Addendum D1

re: **Fort Wayne Community Schools**
Holland and Northcrest Elementary School Renovation
111031.00

issue date: **October 9, 2025**

First Floor Electrical Plans

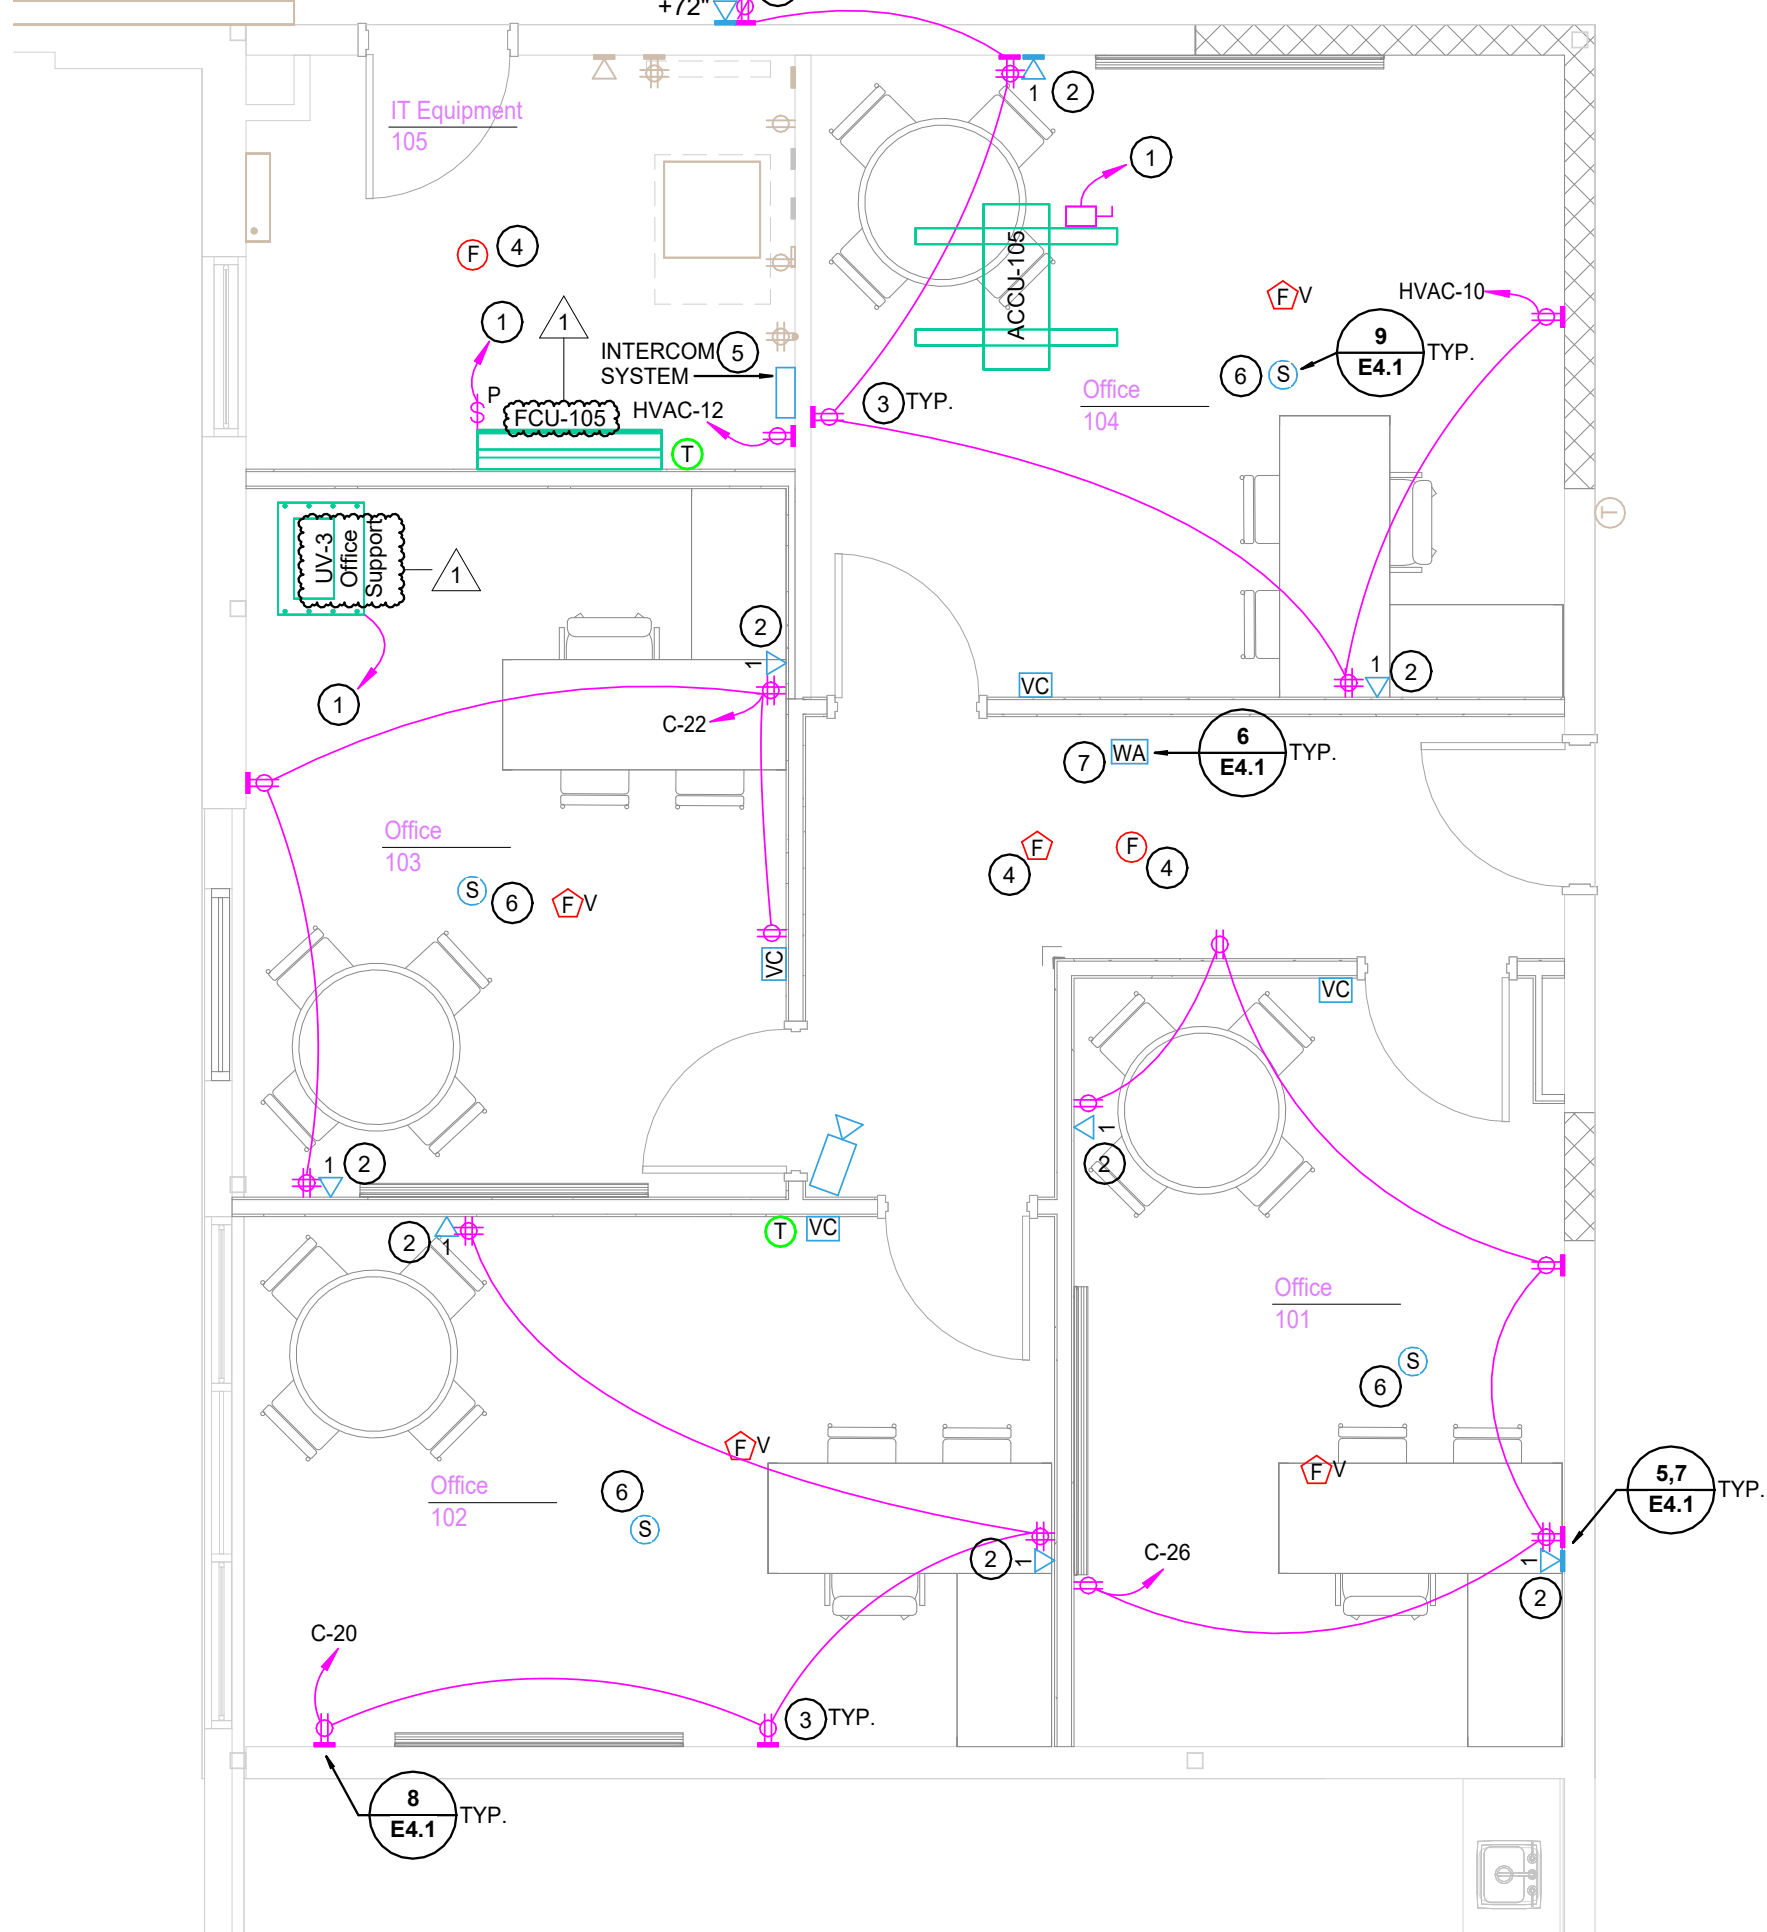
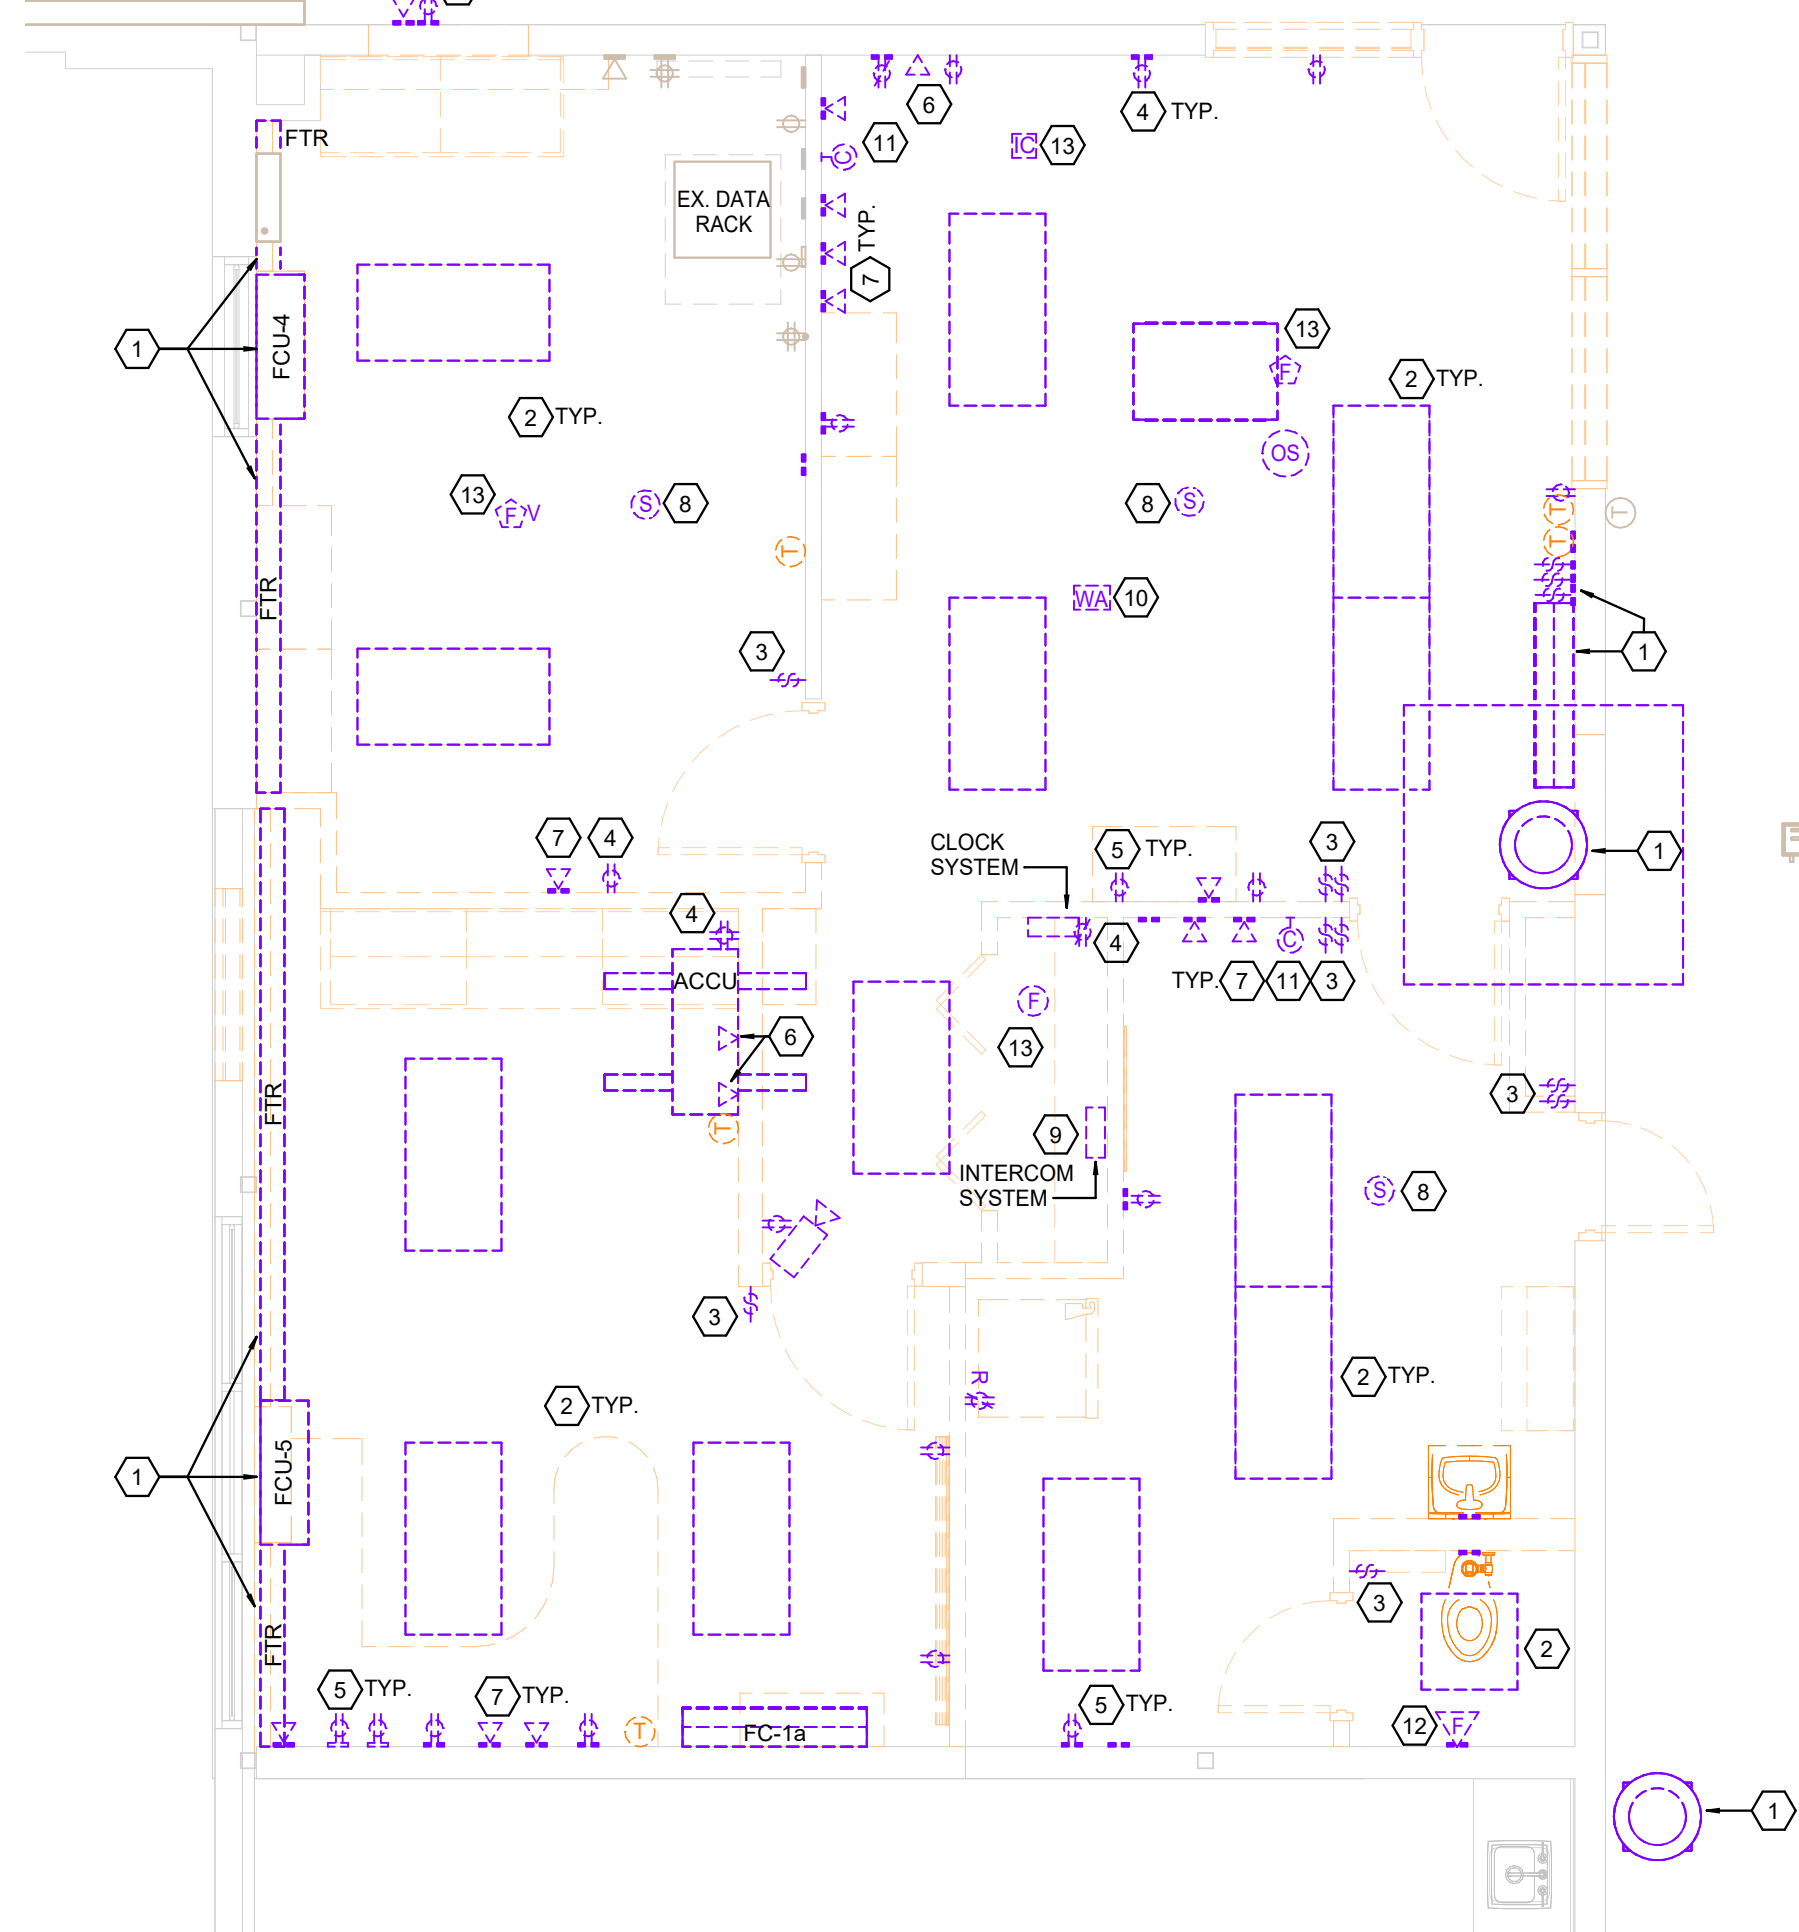
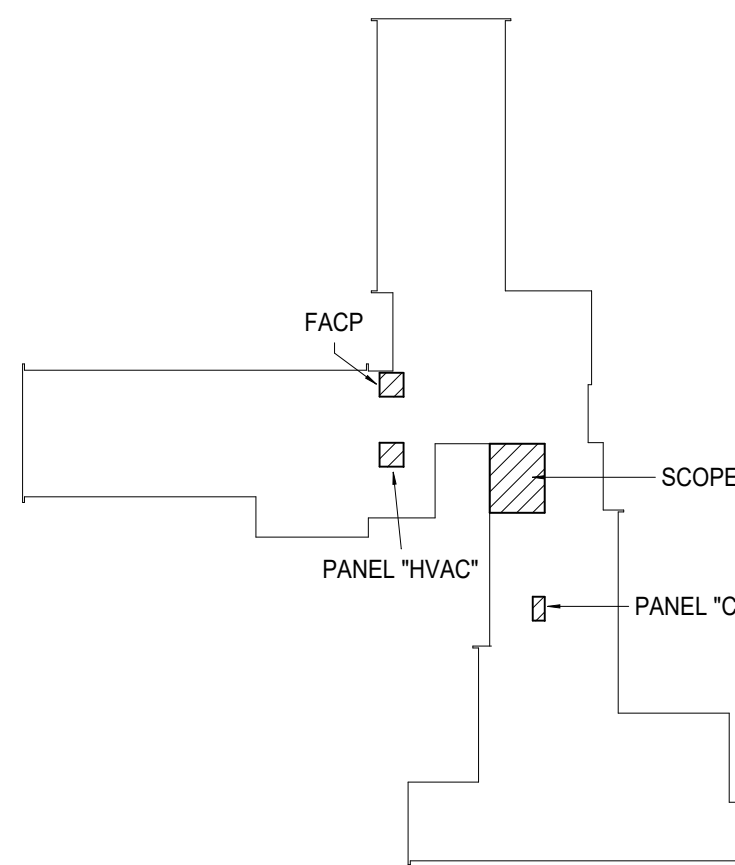
Item #7: Drawing Sheet HO-E2.1, "First Floor Electrical Plans".

- A. Revised new mechanical equipment naming conventions. Refer to supplemental sheet HO-E2.1 for additional information.
